HISTORIC AND DESIGN REVIEW COMMISSION

June 07, 2017

HDRC CASE NO: 2017-229
ADDRESS: 1021 N PALMETTO
LEGAL DESCRIPTION: NCB 1369 BLK 6 LOT N 46 FT OF 8 & 9 ARB A-1
ZONING: R-4 H
CITY COUNCIL DIST.: 2
DISTRICT: Dignowity Hill Historic District
APPLICANT: Ricardo McCullough
OWNER: Imagine Holdings
TYPE OF WORK: New construction of two-story single family residence with rooftop terrace
REQUEST:

The applicant is requesting conceptual approval to construct a new two-story single family residence with a rooftop terrace on a vacant lot located at 1021 N Palmetto.

SITE PLAN

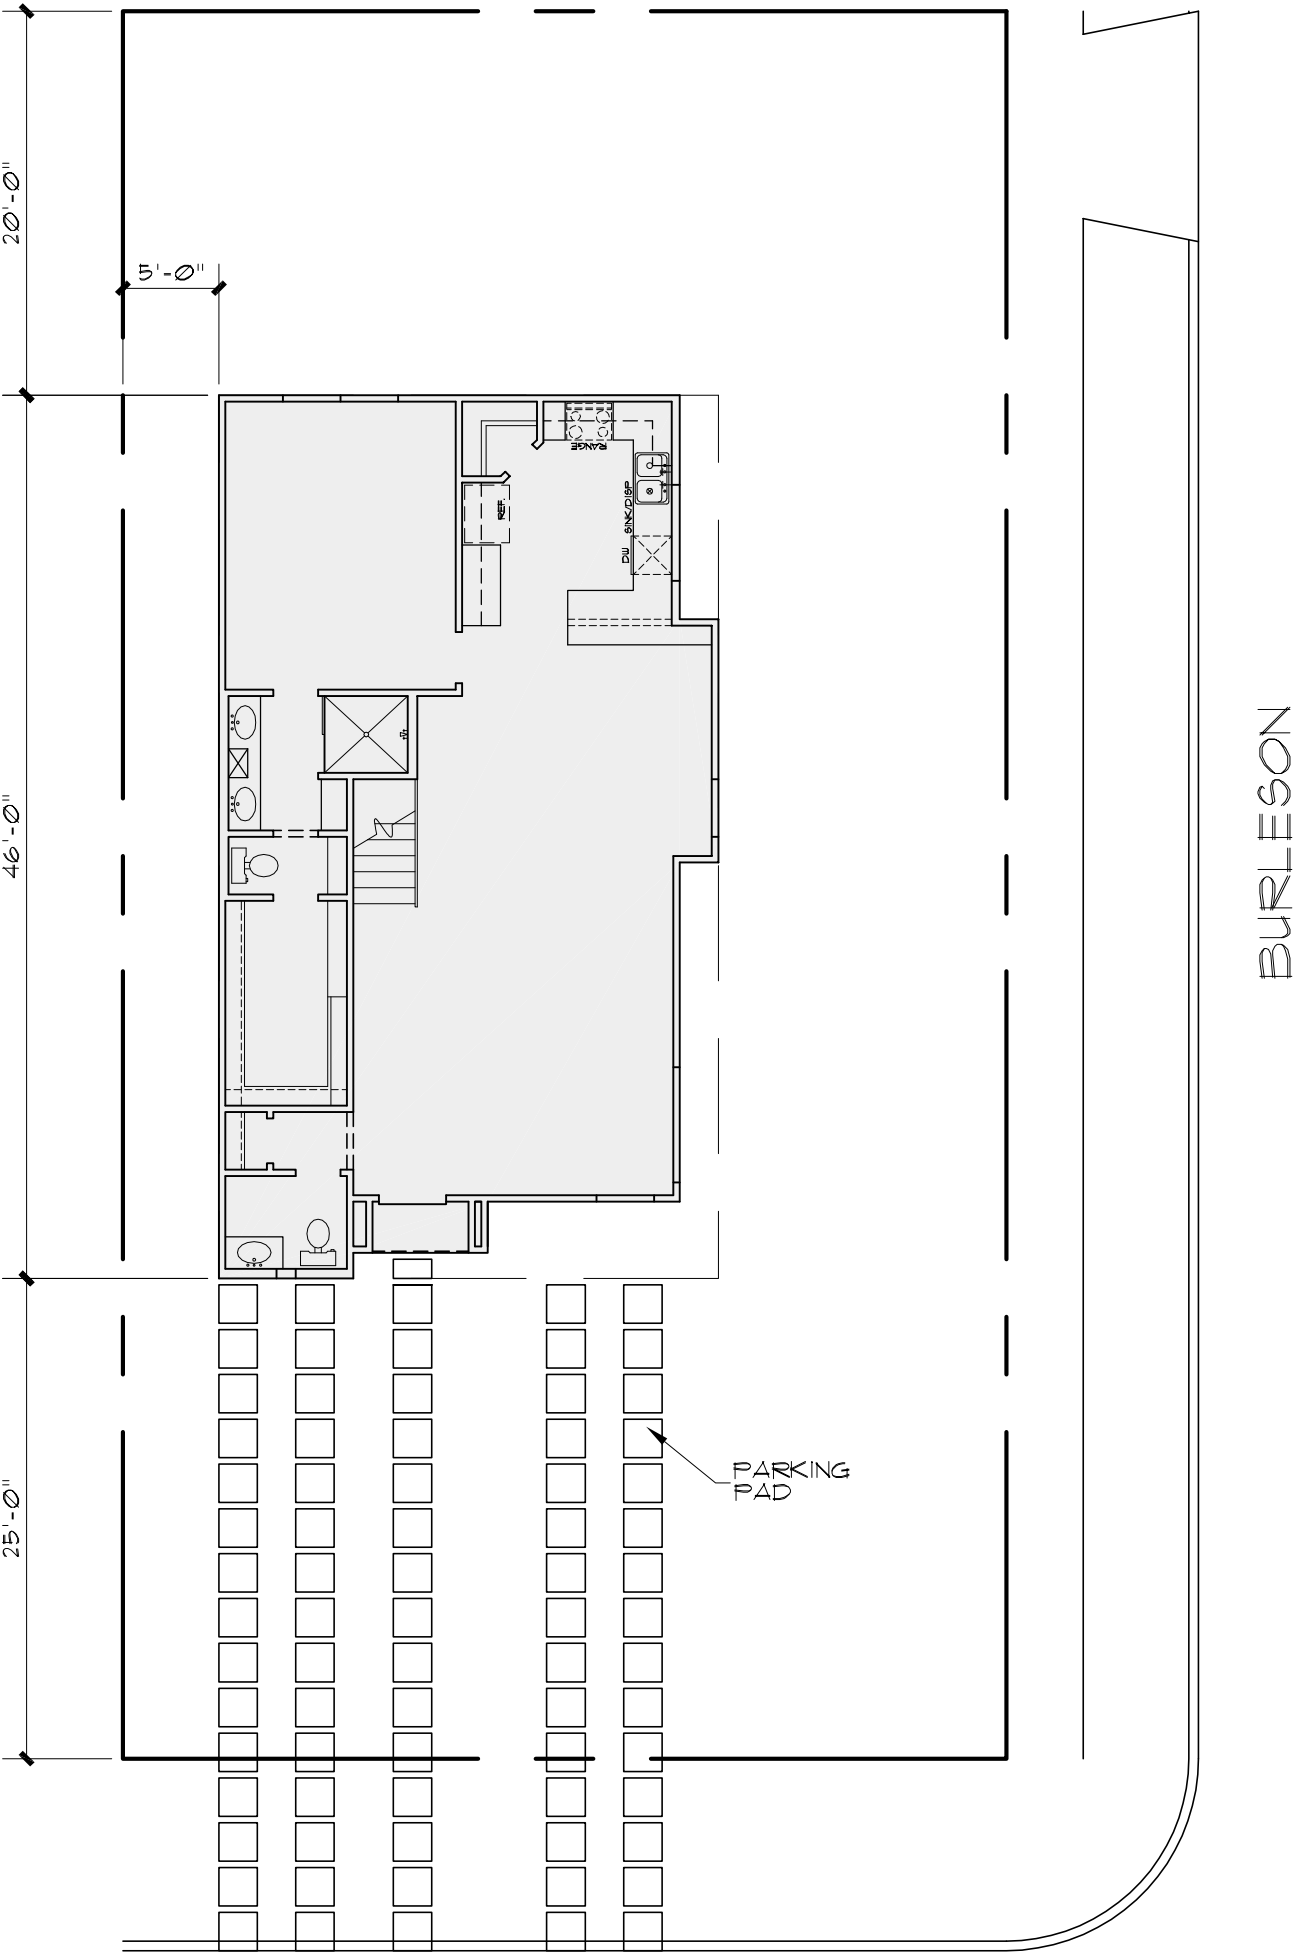
- c. **SETBACKS & ORIENTATION** – According to the Guidelines for New Construction, the front facades of new buildings are to align with front facades of adjacent buildings where a consistent setback has been established along the street frontage. Additionally, the orientation of new construction should be consistent with the historic example found on the block. The applicant has proposed to orient the structure to face N Palmetto Street, which is consistent with the development pattern found on the block. The applicant has proposed a setback that per the

application documents is to be within five feet of the adjacent setbacks. The applicant is to provide field measurements to confirm setbacks of adjacent structures and proposed a setback that is consistent. Staff finds the proposal conceptually consistent with the Guidelines.

- o. **DRIVEWAY: LOCATION** – According to the Historic Design Guidelines for Site Elements, driveways that are similar to the historic configuration found on site or in the district should be incorporated. A driveway is not historically found on the property; however, the placement is consistent with the historic development pattern of the district. Staff finds the proposed location consistent with the Guidelines.

- p. **DRIVEWAY: MATERIAL** - According to Guideline 5.B.i, driveways similar in material found in the district should be used. Pavers are not characteristic of the Dignowity Hill Historic District, where concrete driveways are common. Staff finds the material inconsistent with the Guidelines.

- q. **WALKWAY** – The applicant has proposed to install three individual paver walkways leading from N Palmetto St to the front of the house. One leads to the front door and the other two terminate at the front façade with no entrance. Staff finds the proposed walkway leading to the front door consistent with the guidelines, but finds no precedent in the district for walkways leading to facades with no openings. Additionally, pavers are not consistent with the materials used in front approaches in the Dignowity Hill Historic District, where poured concrete is common.

- a. That the applicant submits a street elevation noting the proposed new construction in comparison with neighboring historic structures to determine the new construction's impact and proposed a consistent setback.

- h. That the applicant implements a concrete driveway in lieu of pavers to be more consistent with the development pattern of the district as noted in findings o and p.

- i. That the applicant reconfigures the front walkway to be more consistent with those found within the Dignowity Hill Historic District as noted in finding q. The applicant should incorporate concrete in lieu of pavers.

ROOF PLAN
SCALE: 1/8" = 1'-0"

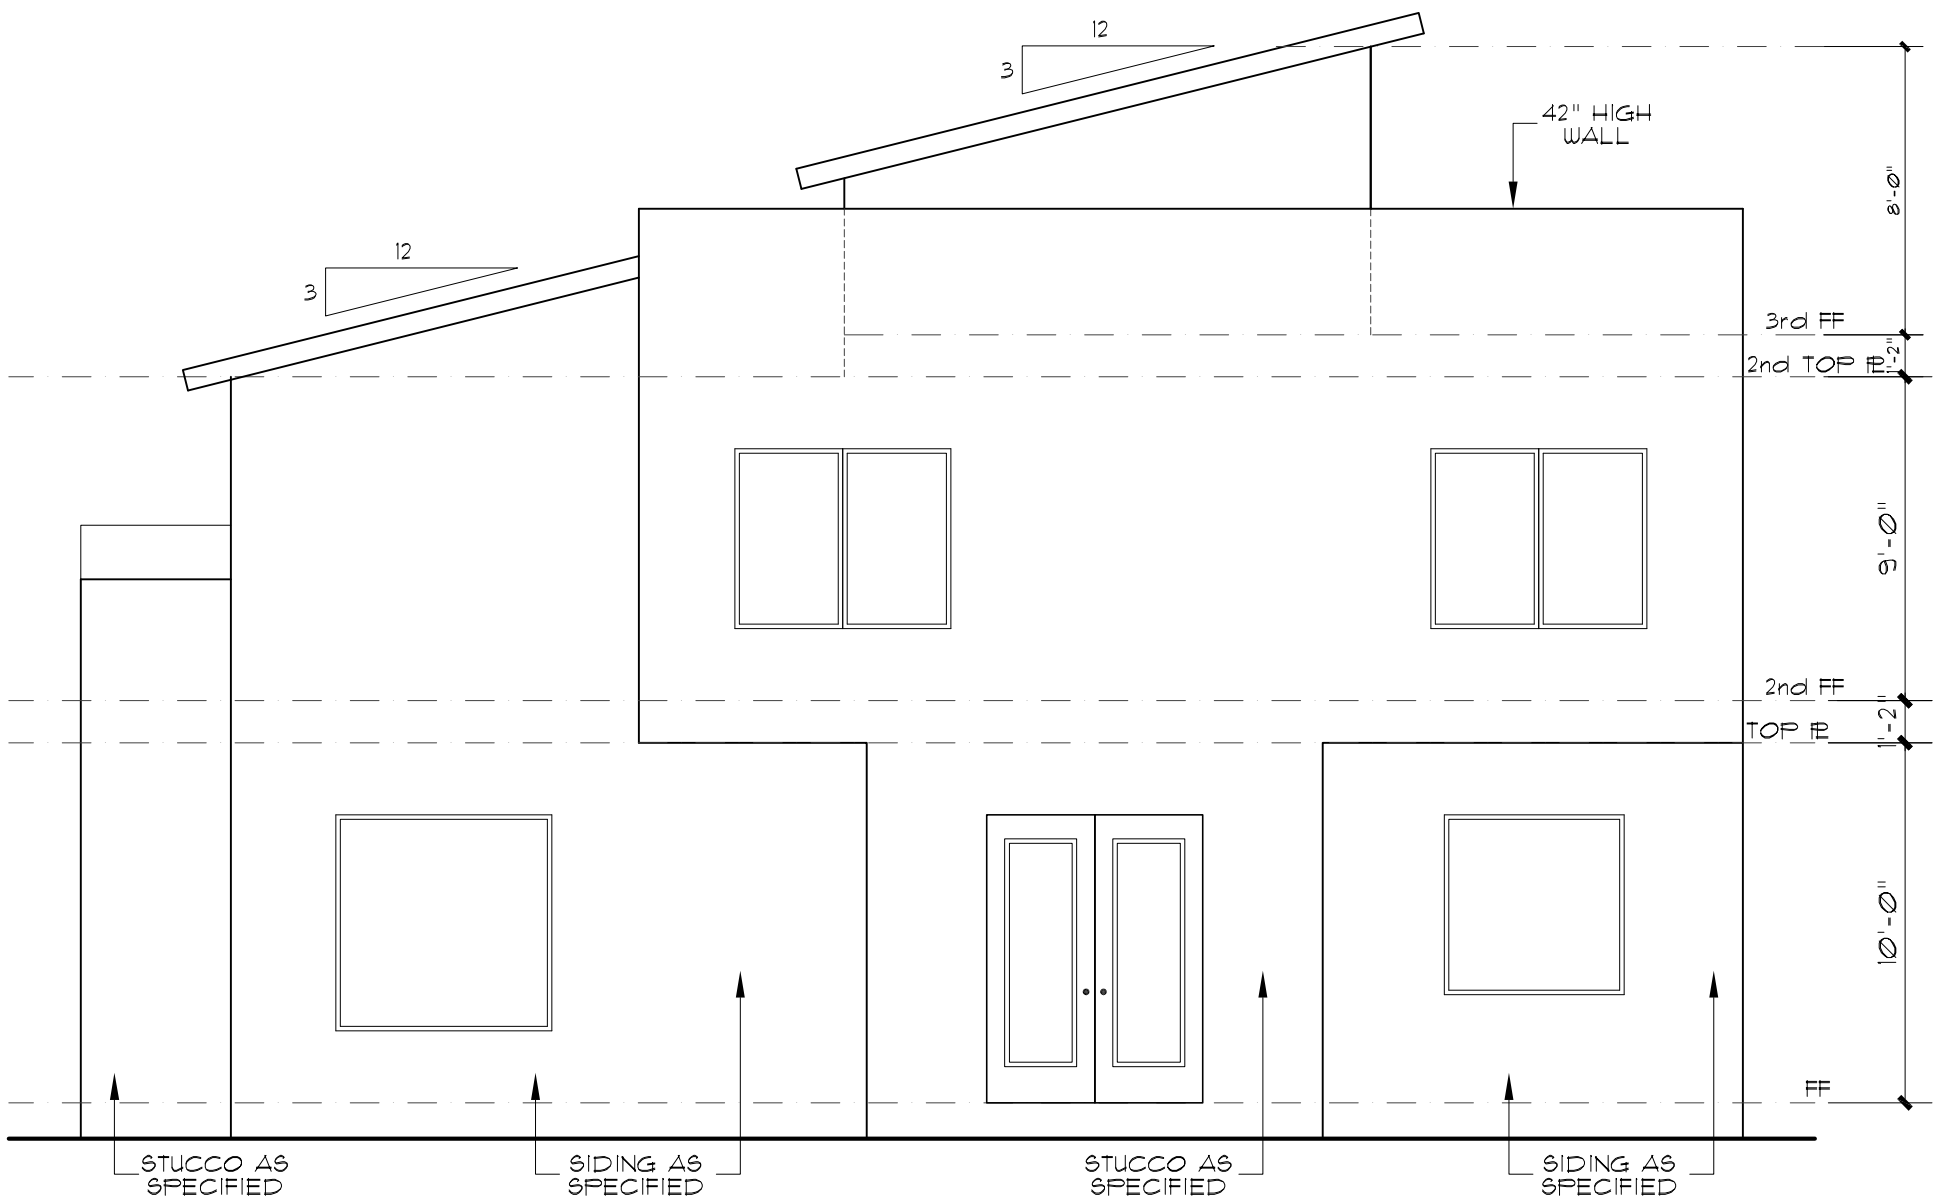
- h. **ROOF FORM** – The applicant has proposed multiple roof forms that include two sloped roofs and a habitable flat rooftop terrace. Both of these proposed roof forms are not historically found in the Dignowity Hill Historic District. Guideline 3.A.iv states that new metal roofs should be constructed in a similar fashion as historic metal roofs. Staff finds the proposed roof forms inconsistent with the Guidelines and incompatible with the district.

- c. That the applicant explores overall massing similar to historic structures in the vicinity as noted in finding f.
- d. That the applicant reconfigures the roof form to be more consistent with the roof forms of the district as noted in finding h.

FRONT ELEVATION

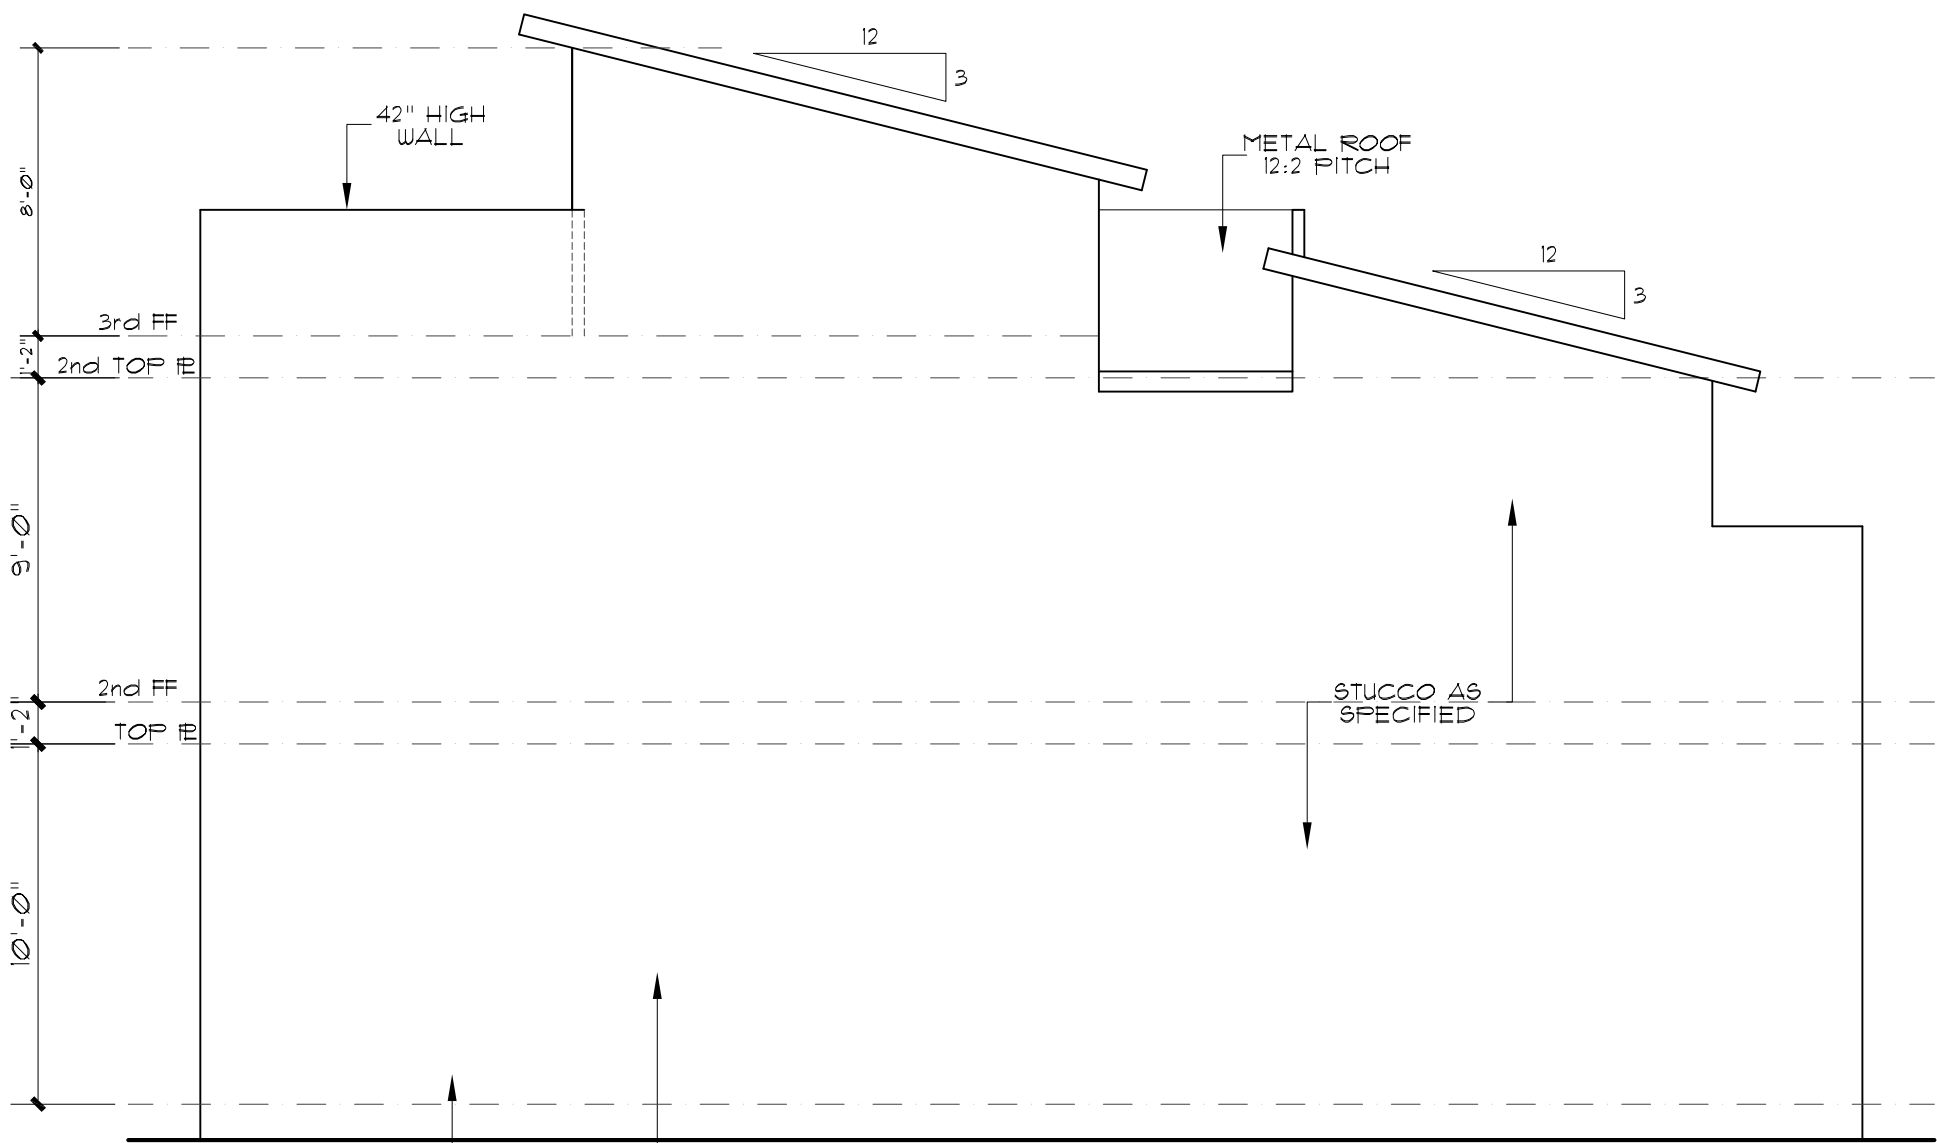
- e. **ENTRANCES: PORCH** – The applicant has proposed a front entrance that projects slightly from the primary setback of the front façade. Historic structures throughout the Dignowity Hill Historic District feature distinct porches that engage the pedestrian streetscape and feature numerous widths, depths and roof styles. The applicant's absence of a definitive porch is not appropriate and inconsistent with the Guidelines.

- f. **SCALE & MASS** – Per the Guidelines for New Construction 2.A.i., a height and massing similar to historic structures in the vicinity of the proposed new construction should be used. The applicant has proposed a two story structure with a rooftop terrace. The highest point of the structure is indicated to be 29'-4" without considering the foundation height. The height is generally consistent with the two-story structures nearby; however, the block is predominantly single-family homes with a maximum height of 20 feet at the roof ridgeline. Additionally, the massing of the structure, primarily the right façade that will face Burleson, is not similar to historic structures and is not appropriate for the site, nor consistent with the Guidelines.

- i. **WINDOW & DOOR OPENINGS: PROPORTIONS AND PLACEMENT** – Per the Guidelines for New Construction 2.C.i., window and door openings with similar proportions of wall to window space as typical with nearby historic facades should be incorporated into new construction. The applicant has proposed window openings that are not consistent with those found on historic structures in the neighborhood, either in width, height, or configuration. Additionally, the left elevation is completely void of fenestration. Guideline 2.C.ii states that blank walls should be avoided. The openings are inconsistent with those found on historic structures in the area, specifically the Craftsman structures found in the immediate vicinity. Staff finds the proposal inconsistent with the Guidelines and incompatible for the district.

- m. **ARCHITECTURAL DETAILS** – New buildings should be designed to reflect their time while representing the historic context of the district. Additionally, architectural details should be complementary in nature and should not detract from nearby historic structures. The architectural details of the proposal are not consistent with context of the neighborhood, which features Craftsman bungalows, Queen Anne cottages, and Folk Victorian homes in the direct vicinity. Staff finds the proposal inconsistent with the Guidelines.

- b. That the applicant proposes a front porch and front massing that are consistent with the Guidelines and complementary of historic front porches found in the Dignowity Hill Historic District as noted in finding e.

- e. That the applicant proposes a fenestration pattern and window opening proportions that are more consistent with the Guidelines, the OHP Window Policy document, and the historic examples found in the Dignowity Hill Historic District as noted in finding i.

- g. That the applicant explores ways to incorporate architectural details and materials that are representative of the historic context of the district as noted in findings k and m.
